AIRBAG WARNING LAMP ILLUMINATED

This Service Information bulletin Replaces SI B65 18 16 **dated September 2016**.

I01 (i3)	 Vehicles from Start of Production (SOP) to April 30, 2016
----------	---

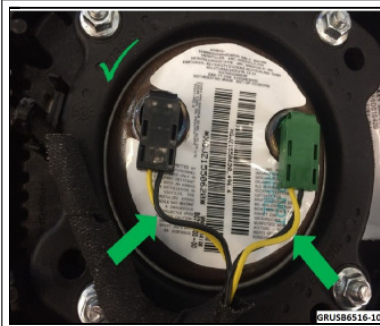
Check resistance thru the clock spring assembly while turning the steering wheel lock to lock. If the resistance exceeds specification while turning the wheel (spec is 2.5 to 5.6 ohms) then the clock spring assembly should be replaced.

Note: **The short harness that connects directly to the driver's airbag "must" never be disconnected**

on the back of the ignitor assembly. If these two connectors are opened, then entire "airbag with jumper harness" has to be replaced.

Make all testing at the single inline connector away from the airbag ignitor

Correct tension free routing

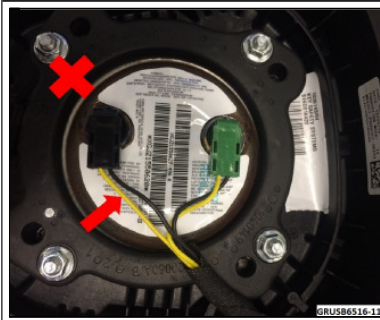
UPDATE! Make sure harness to air bag is not routed under tension. See pictures below.

Incorrect routing. The yellow wire is under tension.
